MODIFICATION REQUEST:

***Headland Park and Northern Cove – Main
Works MP 10_0048 (MOD 9)***

Environmental Assessment Report
Section 75W of the
Environmental Planning and Assessment Act 1979

November 2016

Figure 3: Landscape plan showing outline of proposed alternative physical interpretation device
(Source: RTS)

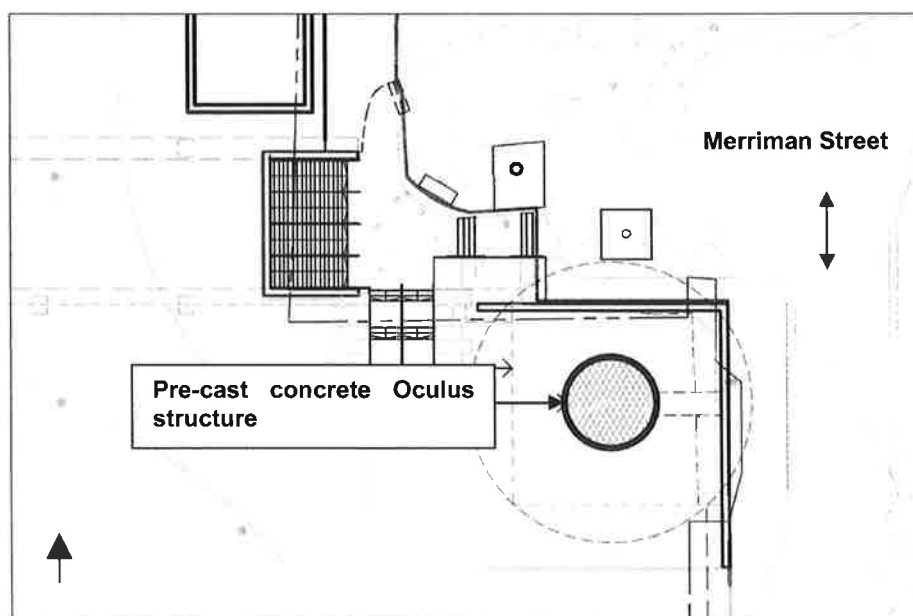
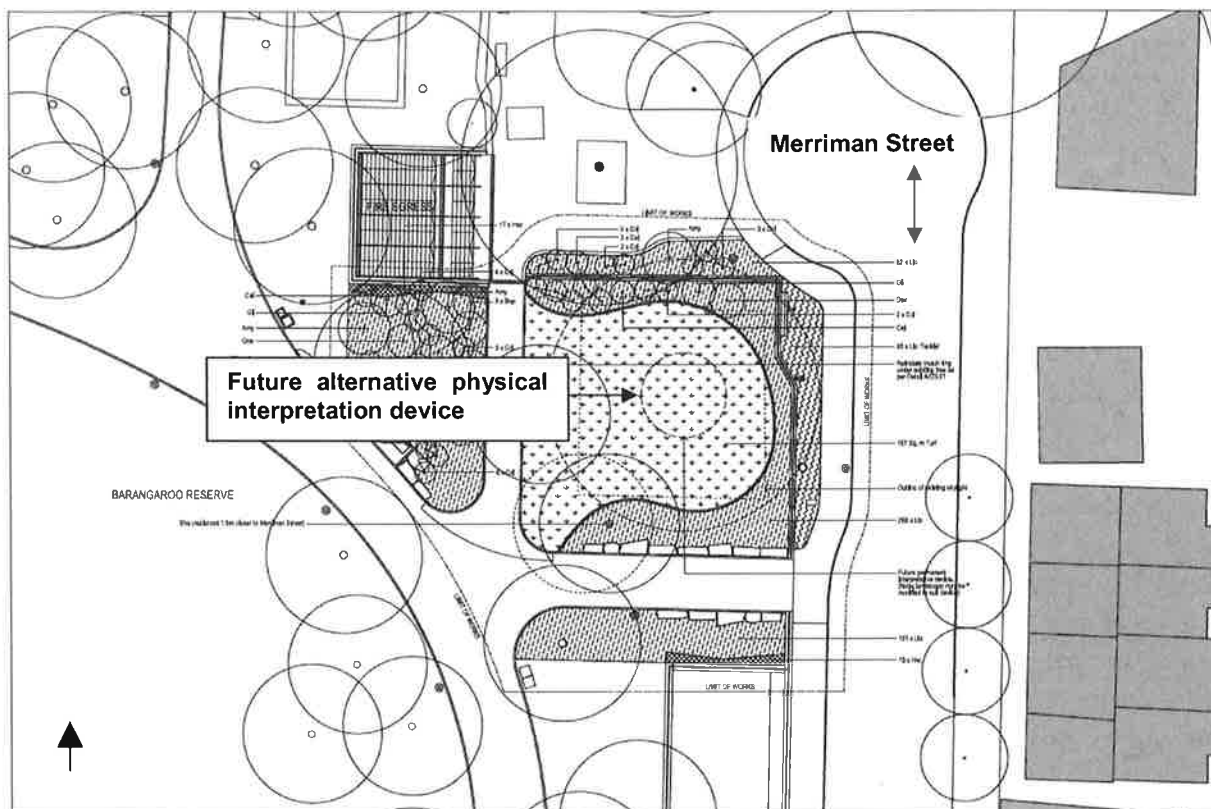
This modification application (as amended by the Response to Submissions) seeks to modify Condition A2A to replace the approved physical interpretive device ('Oculus') at the site of the HCT (**Figure 2**) with an alternative physical interpretation device (**Figure 3**). The application also includes an Interpretation Plan (as required by Condition B41 of the project approval) which identifies proposed interpretive devices to convey major heritage themes for the site.

The Department notes few details have been provided regarding the specific design of the proposed alternative physical interpretation device with the landscape plan (**Figure 3**) showing the outline of the device only. However, the Department supports this approach in principle as it is supported by both Council and the Heritage Office and the proposed device would be similar to the Oculus in that it would reflect the original stem footprint of the HCT at its original location.

The Department is therefore satisfied the proposed alternative physical device would continue to provide an appropriate mechanism to interpret the HCT and the maritime history of Sydney Harbour, subject to recommended conditions requiring the BDA to:

- finalise the detailed design of the device in consultation with the Council, the Heritage Office and other key stakeholders;
- ensure the design of a high quality, has visual prominence, is of a three-dimensional sculptural quality and is designed by a public artist and heritage expert;
- submit the detailed design documentation to the Secretary for approval; and
- complete the installation of the device by 31 December 2017.
